**WEST SUSSEX COUNTY COUNCIL  
STRATEGIC PLANNING CONSULTATION**

**DATE: 9th February 2017**

**SUBJECT: LU/182/15/PL - Variation of conditions 4, 6, 7, 8, 39 and 42 imposed under planning reference LU/47/11/ relating to list of plans, illustrative masterplan, CHP plant building, Design Statement, bus stops & traffic improvements.**

**LOCATION: Land North of Toddington Lane, Littlehampton, BN17 7PP.**

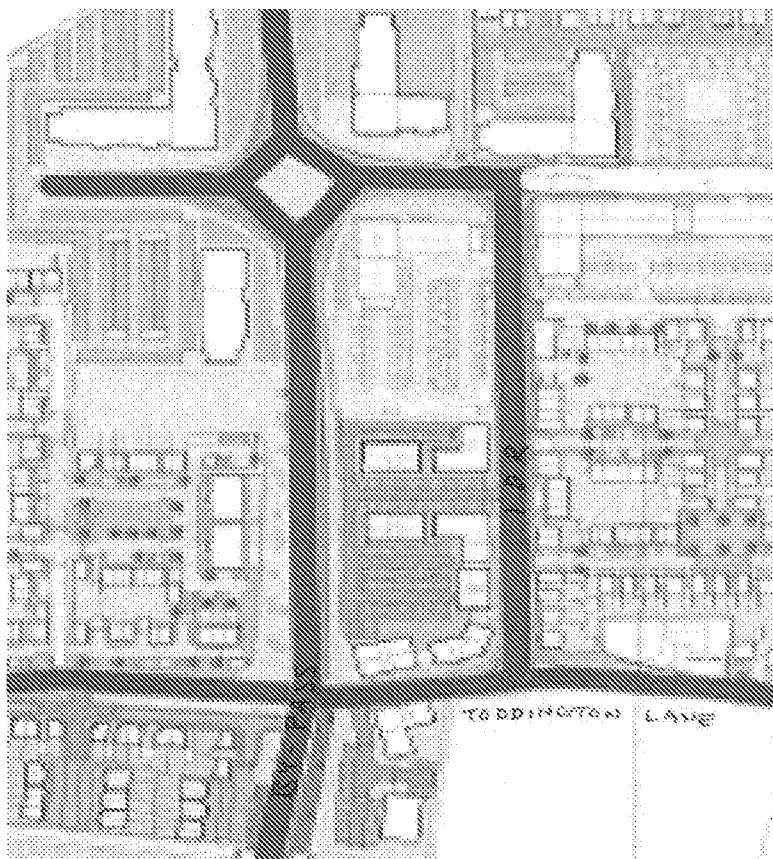
- Road widths (residential access roads – **NOT** Strategic Roads nor loop/spine road) – Minimum road width shall be 4.8m. For reasons of safety and accessibility, 4.1m wide roads/access drives (as quoted in the Development Framework Document) should not be provided.
- Visibility splays – To comply with recorded traffic speeds and informed by Manual for Streets and/or Design Manual for Roads and Bridges as appropriate.
- Extent of road adoption – WSCC will adopt roads in red as shown below given their strategic nature (blue line is existing adopted public highway):

- *Speed controls for internal roads (and speed limits) (comments do **NOT** refer to Strategic Roads shown in red above other than IDR and associated connection) –* Although a 20mph speed limit is suggested in the Development Framework Document, actual speeds will be determined by final road design. Therefore, it should not be assumed that 20mph road speeds will be achieved although that is what should be aimed for. Applicant should aim for this through careful design and associated speed controls. Particularly with regard to the main spine road 'looping' through the development, no evidence is shown of speed controls that will be necessary to manage traffic speeds. Appropriate junction treatments and other traffic management features for this road must be provided at appropriate locations. The onus will be on the applicant to demonstrate what and how traffic speeds will be managed on all roads proposed at the detailed design/reserved matters stages. As the spine/loop road is proposed to be a bus route, this should also be safety audited at the detailed designed/reserved matters stage.
